Maryon House, 115-119 Goldhurst Terrace
London, NW6 3EY

Basement Impact Assessment
Audit

For
London Borough of Camden

Project Number: 12336-89
Revision: F1

Figure 6

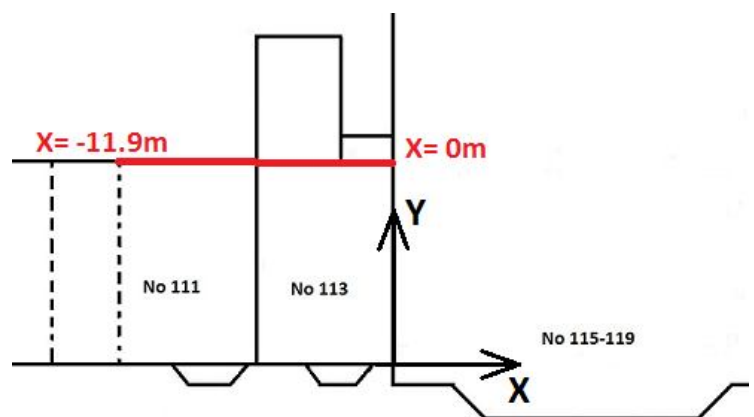
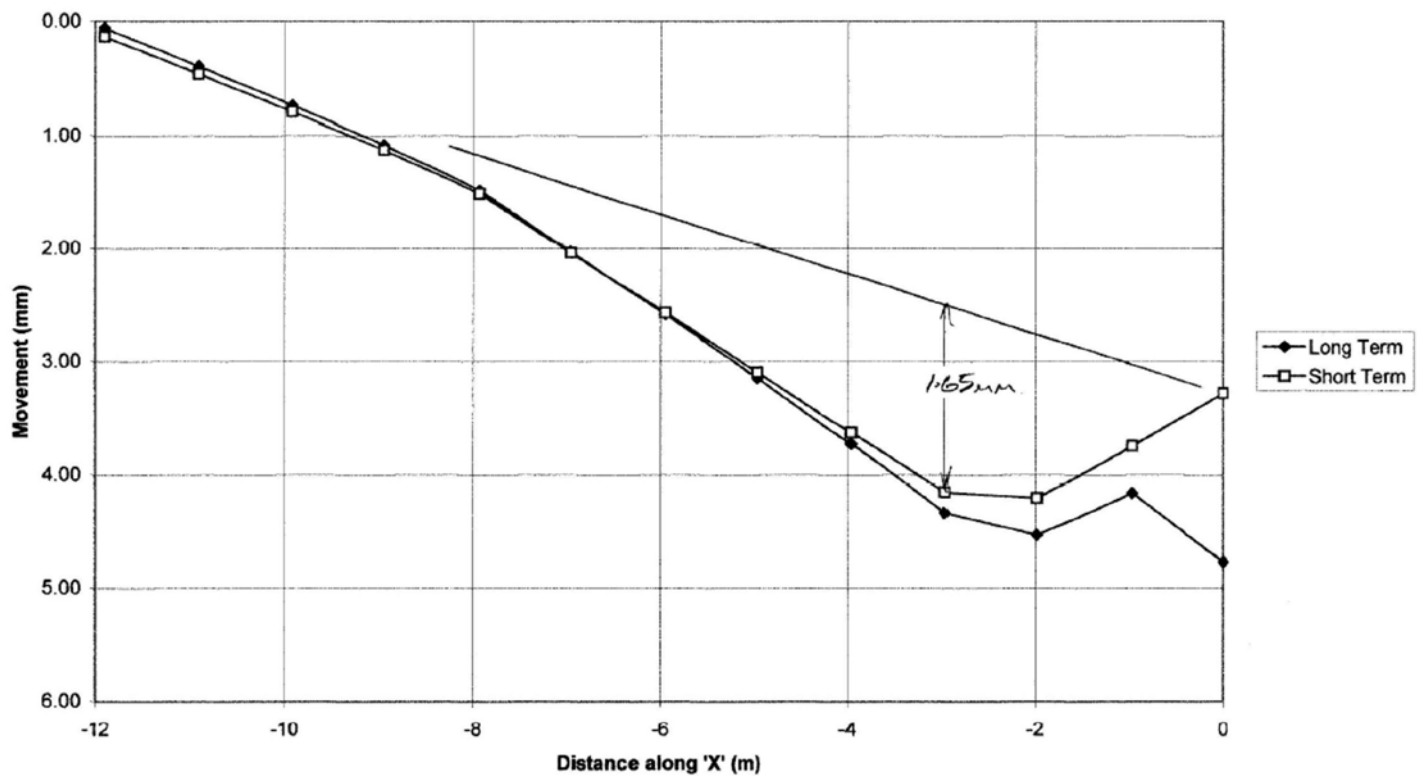
Profiles of short- and long-term vertical ground movement along the rear wall of Nos 111 and 113 Goldhurst Terrace have been calculated and plotted in Figure 6.

The wall is taken to be approximately 11.9m long and 9m high above ground level. It lies in the position shown on the plan in Figure 6.

The maximum predicted wall distortion (Delta – as defined by Burland, Ref 2) is 1.65mm within the length of the wall. The limit on tensile strain for 'very slight' damage is 0.075% (Ref 2), therefore the ratio of deflection ratio to limiting tensile strain is 0.185. By reference to Figure 4 (Ref 2 Figure 6) a horizontal strain/limiting tensile strain ratio of 0.83 is obtained, indicating that a horizontal strain of 0.062% is acceptable for a 'very slight' category of damage. The analysis does not take into account the stiffness of the wall and is conservative in this respect.

Figure 10

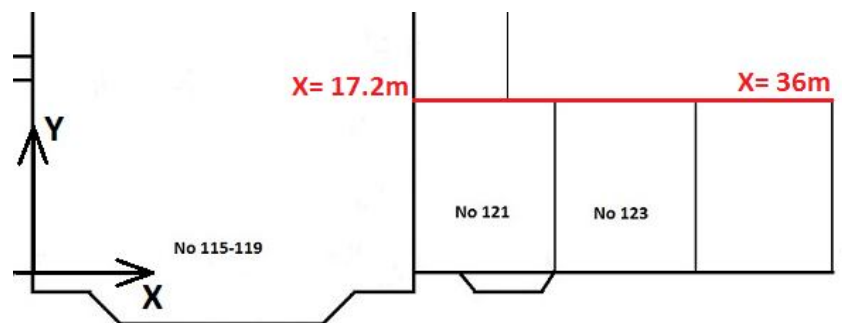
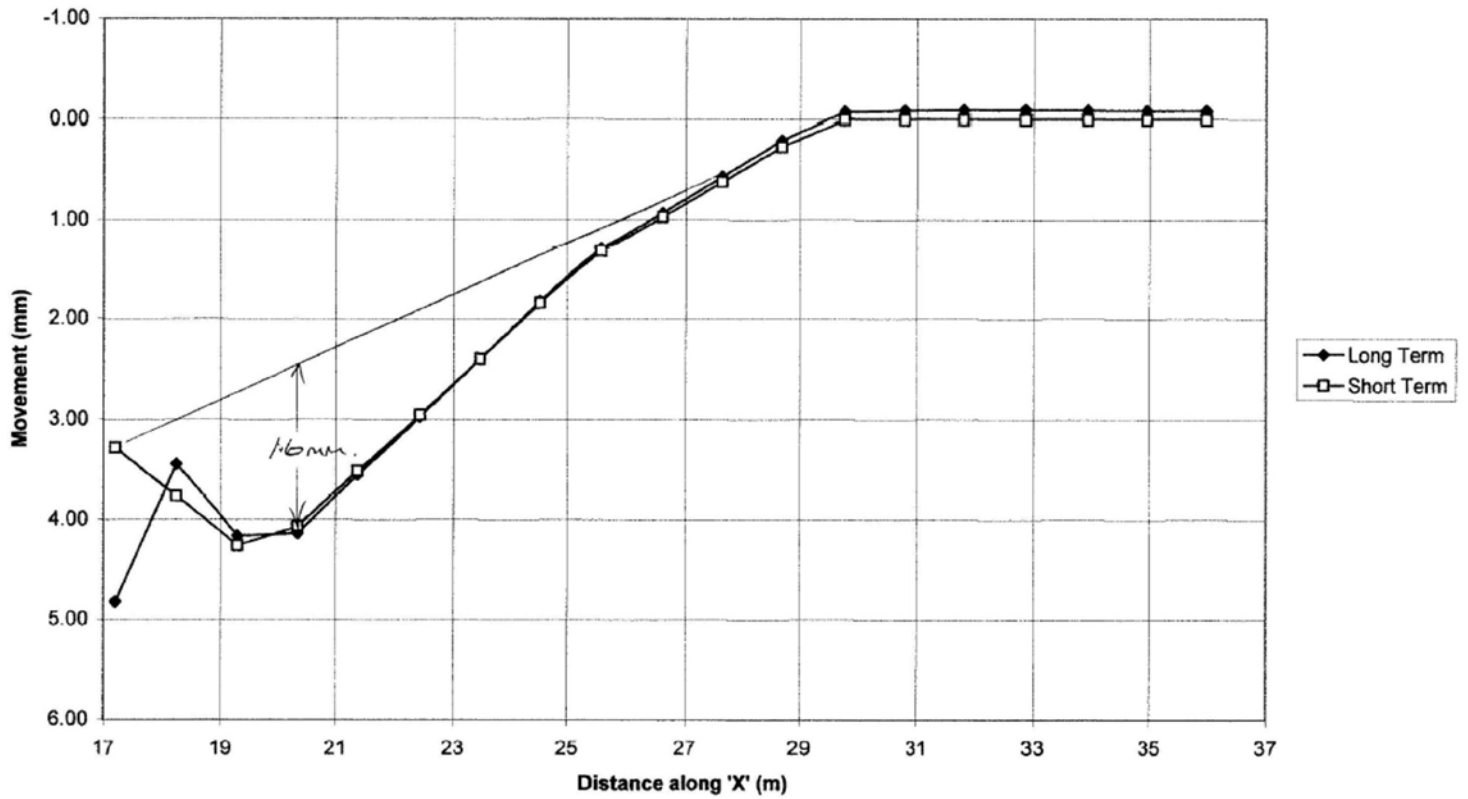
Profiles of short- and long-term vertical ground movement along the rear wall of Nos 121 to 125 Goldhurst Terrace have been calculated and plotted in Figure 10.

This wall is taken to be approximately 18.8m long and approximately 9m high, above ground level. It lies in the position shown on the plan in Figure 10.

Two modes of distortion are evident from Figure 10; sagging close to the excavation, and hogging over a greater part of the wall. Hogging is usually the more damaging mode, but from Section 5.3 above it is noted that maximum average horizontal strain only occurs within approximately 1.5 x wall depth of the excavation, in this case this is approximately 6.1m (to X= 23.3m in Figure 9). Therefore the local sagging is considered to be more critical.

This predicted sagging wall distortion (Delta – as defined by Burland, Ref 2) is 1.6mm within a 10.4m length of the wall. The limit on tensile strain for 'very slight' damage is 0.075% (Ref 2), therefore the ratio of deflection ratio to limiting tensile strain is 0.20. By reference to Figure 4 (Ref 2 Figure 6) a horizontal strain/limiting tensile strain ratio of 0.83 is obtained, indicating that a horizontal strain of 0.062% is acceptable for a 'very slight' category of damage.
